01 Section H-H - Option 1 Garden Terrace Sections

02 Section I-I Garden Terrace Sections

Friends House Garden
Elevation
Terrace Sections H & I - PROPOSED

Scale: As A3: 1:50	Job Number: 1498
Date: 03/02/2014	Drawing: LB
Drawing Status: STAGE E	Checked: JD
Drawing Number: 1498-0710-S-04	Revision: 04

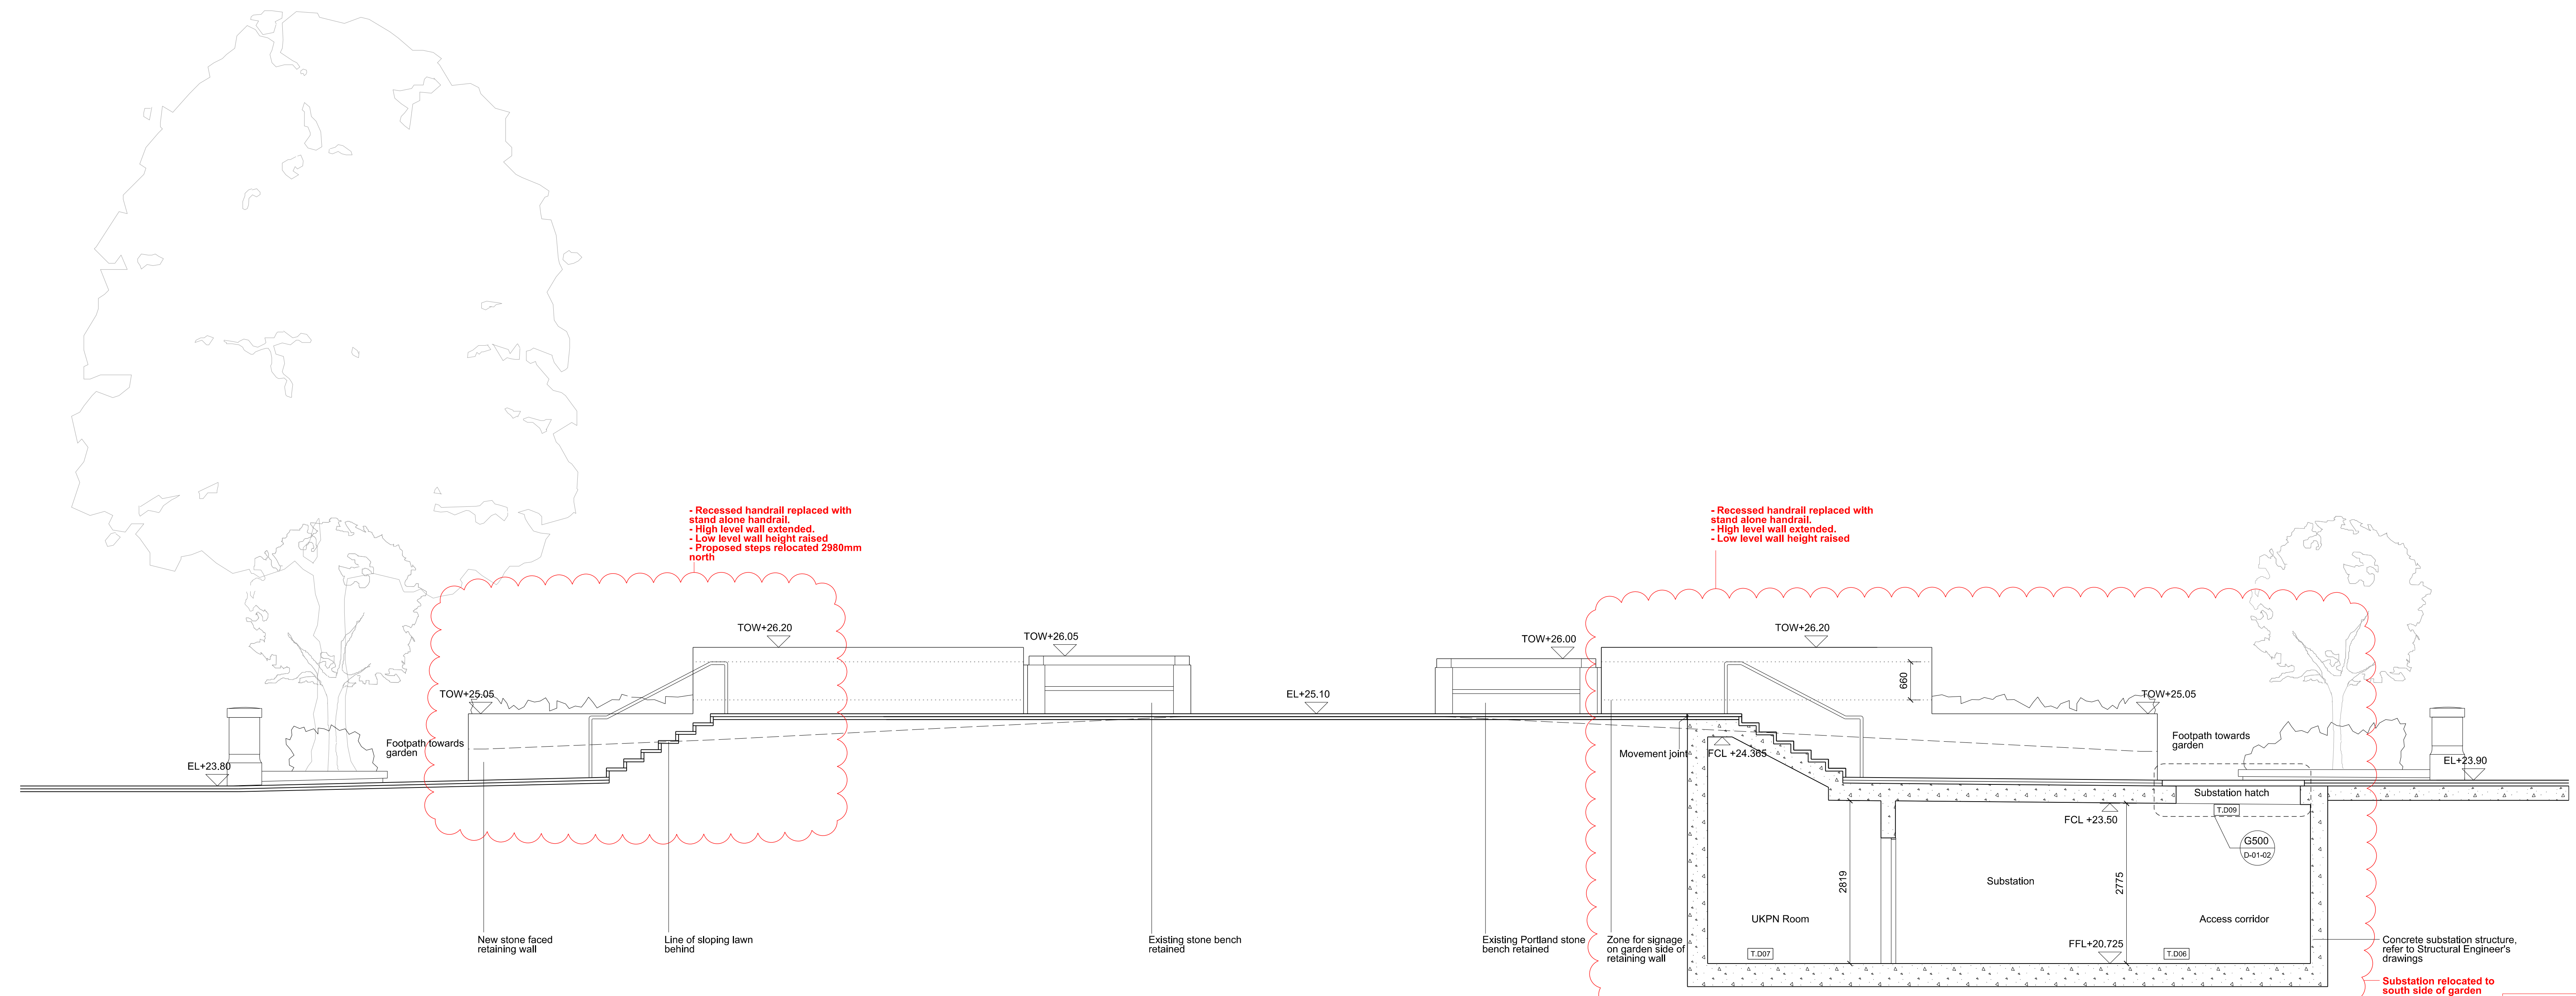
T.D01 - Secondary doors replaced with new automatic glazed doors. Existing timber outer doors retained

Balustrade amended - Door fenestration amended to meet planning condition

Proposed steps relocated 280mm north

- Recessed handrail replaced with stand stone handrail.
- High level wall extended.
- Low level wall height raised.
- Proposed steps relocated 280mm north

- Recessed handrail replaced with stand stone handrail.
- High level wall extended.
- Low level wall height raised
